## ADDENDUM –Layout Changes and Impact on Noise 23/08/2018

**Figure 1 – Updated Site Plan for 3735 St. Joseph Boulevard**

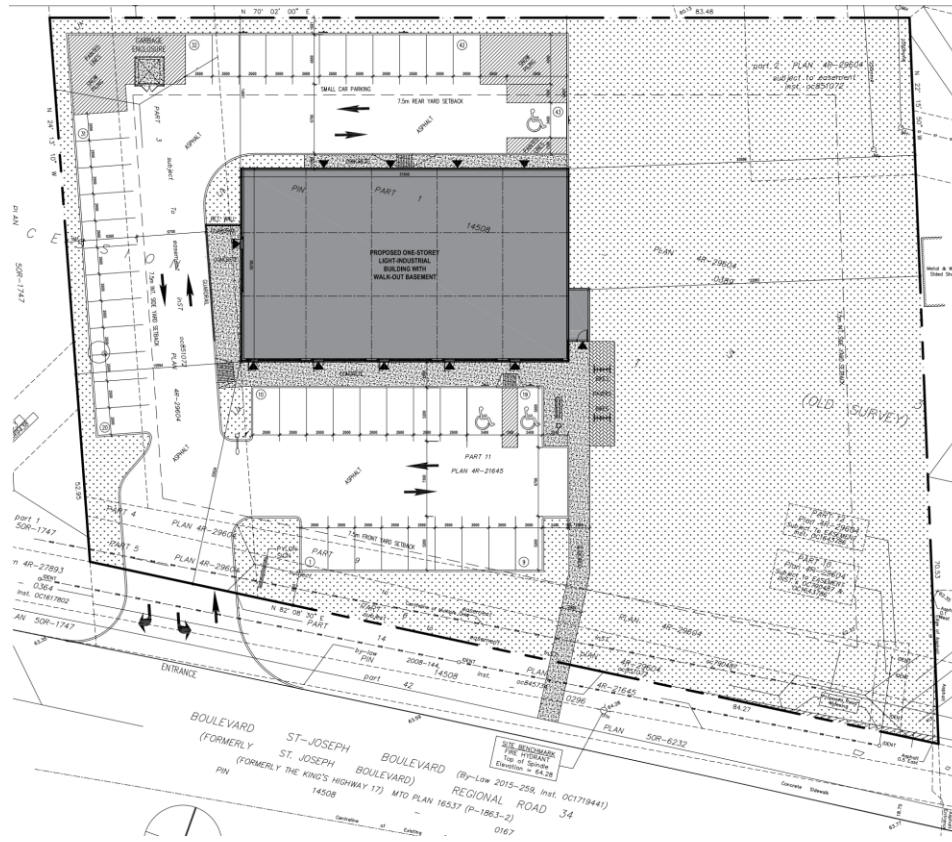
The layout of this development has been modified from two 2-storey buildings to a single 1-storey building since the original study was completed. The purpose of this addendum is to evaluate the traffic and environmental noise impacts of the modifications to the development. Figure 1 below shows the updated site plan.
